RESOLUTION

R219 – 2023

Certificate of Appropriateness for work in the Historic Districts:

**Historical Architectural Review Board
COA Final Review Sheet**

**Front façade of 29 N. 12th Street, 2019.
(Google StreetView)**

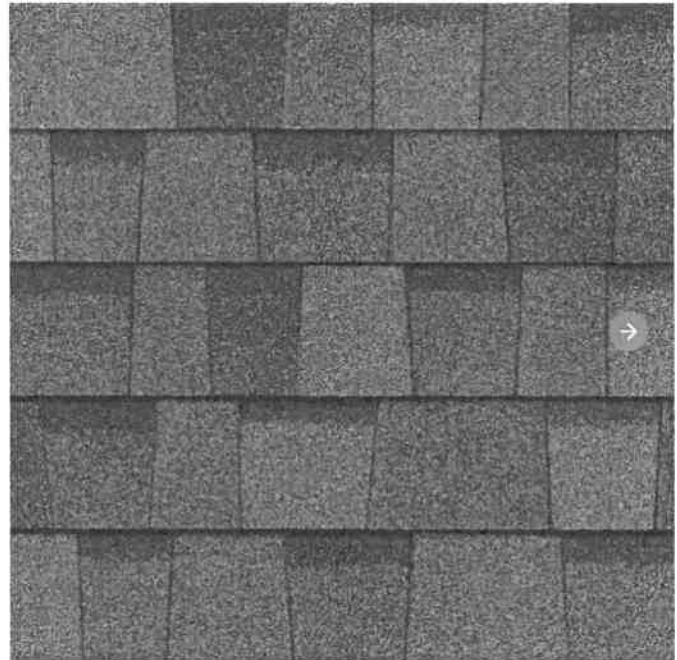
The applicant contends that the existing slate roof needs to be replaced. The roof is visible from the right-of-way at 12th Street but not visible from Amanda Street at the rear, owing to vegetation.

The application proposes to install Owens Corning TruDefinition Duration asphalt shingles. The shingles have an exaggerated tapered shape, which the guidelines explicitly advise against (p. 41). Staff recommends using an appropriate asphalt shingle that more closely replicates the historic slate in dimension, shape, profile, color, exposure, and overall appearance, such as GAF Slateline shingles or an equivalent.

The HARB agreed with the staff recommendation of denial of the proposed shingles, since the guidelines advise against using an exaggerated tapered shape and found that the proposed shingle does not provide a reasonable match to the existing slate.

- The proposed shingles have an exaggerated tapered shape to replicate cedar shakes, and the guidelines advise against the shape;
- An appropriate asphalt replacement shingle should replicate the original slate in dimension, shape, color, exposure, and overall appearance, such as GAF Slateline shingles or an equivalent.

**Front façade of 205 N. 9th Street, 2021.
(Google StreetView)**

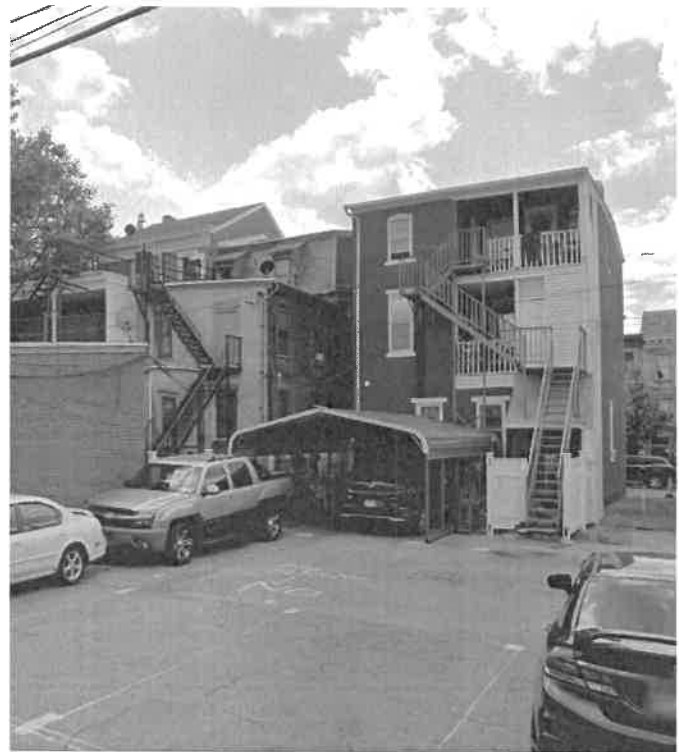
Staff comments that the carport meets some but not all of the guidelines in Section 5.2 New Accessory Buildings. The structure meets the guidelines for its height, massing, size, and scale, but does not comply with the guidelines related to proportion, materials, detailing, and fenestration. Staff notes that the carport is defined in the ordinance as a structure but not as a building. Because the carport is not defined as a building and is easily reversible, staff argues that it should be generally compatible with the district but may not need to meet the specific requirements and details of a typical accessory building, such as a garage. Staff contends that the structure does not have an adverse impact on the district, since it is reversible and located on a service alley.

For the floorboard replacement at the front porch, staff notes that Guideline 3.7.8 allows for composite wood decking, provided the boards are similar to the original dimensions. Staff questions whether the proposed decking matches the dimensions of the historic floorboards and recommends a product that replicates the tongue and groove construction and dimensions more closely.

Regarding the front porch, Mr. Huber stated that the proposed material is decking but that a porch floorboard with solid nosing should be used. He added that the HARB regulates integral color and would need to know what color is being used. The applicant responded that he would like to use red. Mr. Lichtenwalner stated that red, gray, or grayish-tan would be appropriate.

- The carport must receive zoning approval;
- The carport must be appropriately secured to the ground to prevent uplift;
- The porch floorboards may be composite and of a red, gray, tan, white, or similar color; and
- The floorboards should be installed according to the manufacturer's specifications without altering the porch posts or railings.
